ADDENDUM NO. 2

DFS TERMINAL, HANGAR, AND APRON DEVELOPMENT

CITY OF DEFUNIAK SPRINGS, FLORIDA

Addendum Date: February 25, 2022

3 WALL SECTION 9
SCALE: 3/4" = 1'-0"

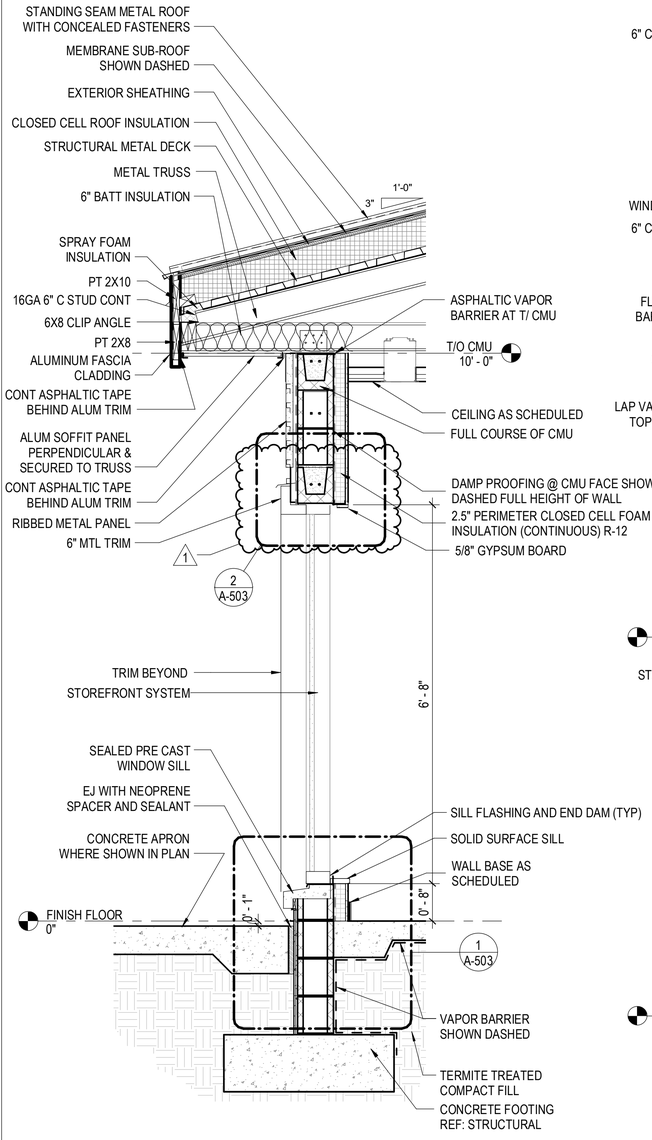
12.	A-304 – CANOPY SECTIONS	• Details 1 & 2 ○ Added “TYP” (typical) to the tempered glass door notes.
13.	A-313 – WALL SECTIONS	• Detail 3 ○ Corrected conflicting header graphic.

5 GLULAM TRUSS INTERSECTION
SCALE: 1/2" = 1'-0"

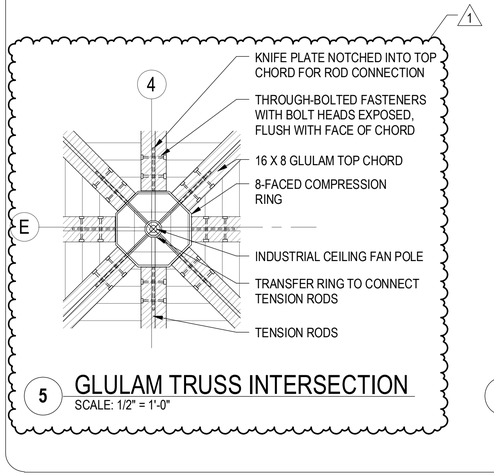
17.	A-403 – INTERIOR ELEVATIONS	• Accessories Schedule: ○ Revised Keynote A10’s model to be “JACKNOB-4003”.
18.	A-501 – GLULAM ASSEMBLIES	• Detail 5: ○ Corrected graphics.

3 LIGHT COVE DETAIL
SCALE: 3" = 1'-0"

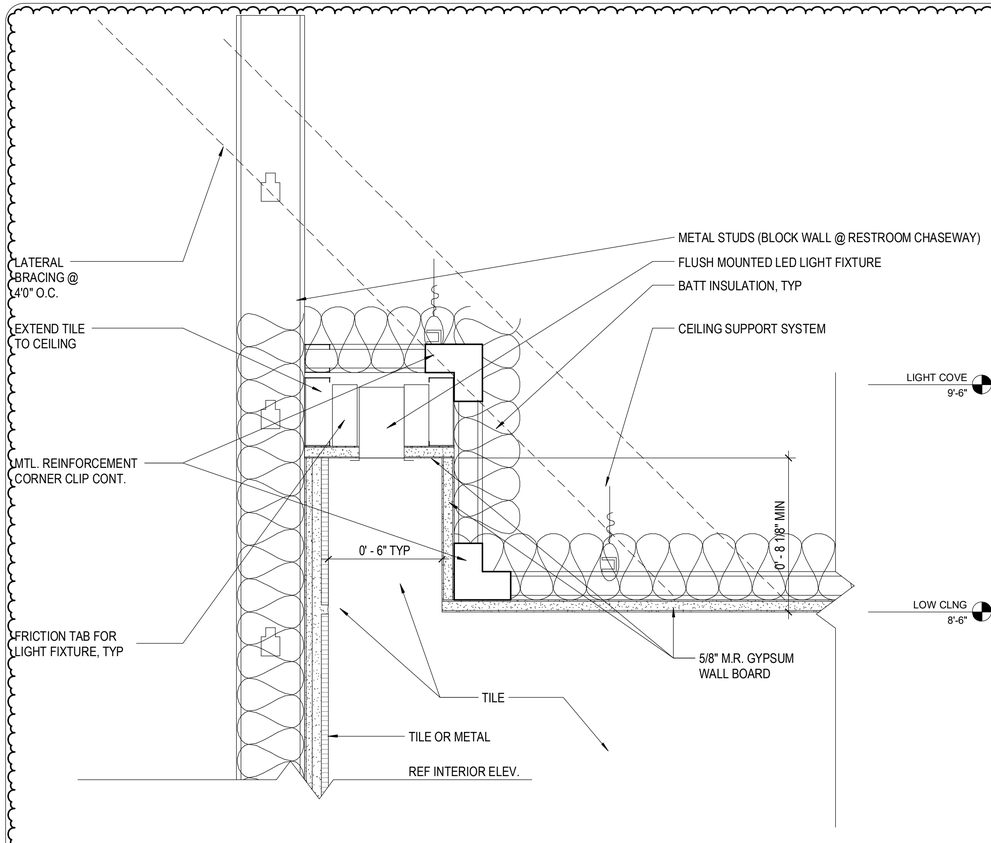
19.	A-506 – DETAILS	• Details 1 & 3: ○ Revised the recessed LED light cove framing detailing.

2 DETAIL SECTION - DISPLAY CABINET
SCALE: 3/4" = 1'-0"

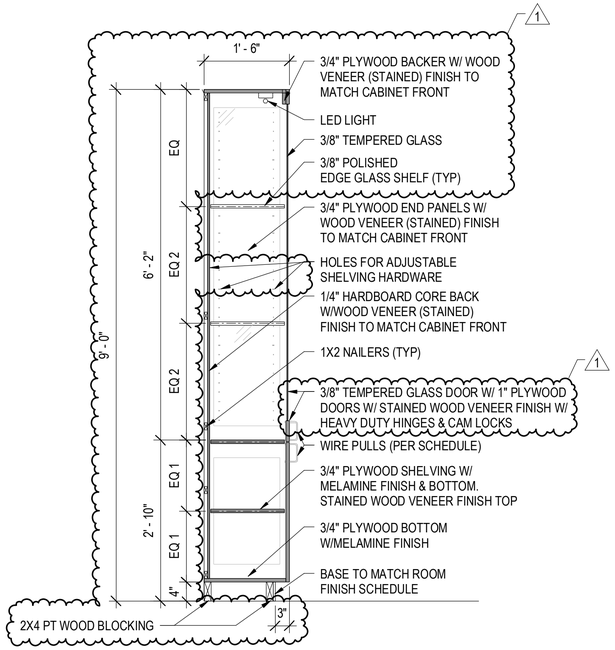
24.	A-704 – MILLWORK DETAILS	• Detail 2:
		  ○ Updated door thickness to 1" and included note for heavy duty hinges with cam locks.
		  ○ Indicated 3/8" tempered glass.
		  ○ Added note for a ¾" backer at door head to close against.
		• Detail 6:
		  ○ Clarified meeting room receiver channel and wood blocking requirement notes.
		  ○ Defined glazing thickness and joints.
		  ○ Provided additional detail for metal joist structure above and concrete beam interface.

5 WEATHERVANE DETAIL
SCALE: 1 1/2" = 1'-0"

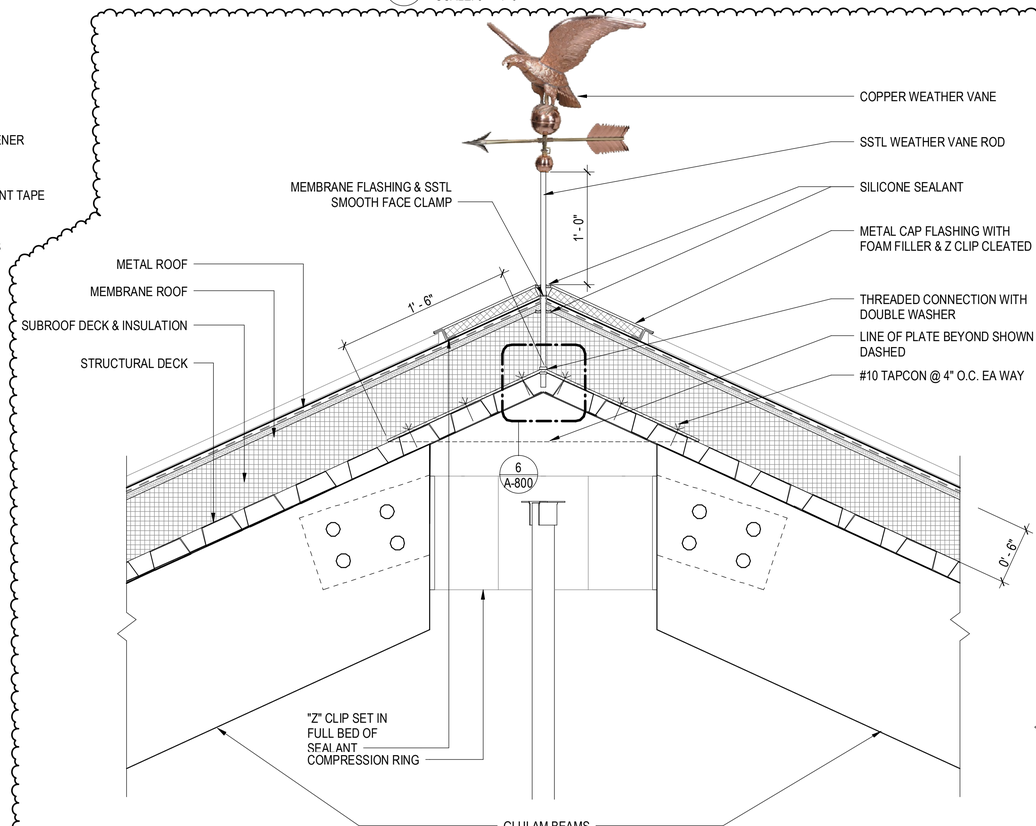
25.	A-800 – ROOF DETAILS 01	• Details 5 & 6:
		  ○ Corrected graphics.
		  ○ Added a 2nd nut at the weathervane base detail.
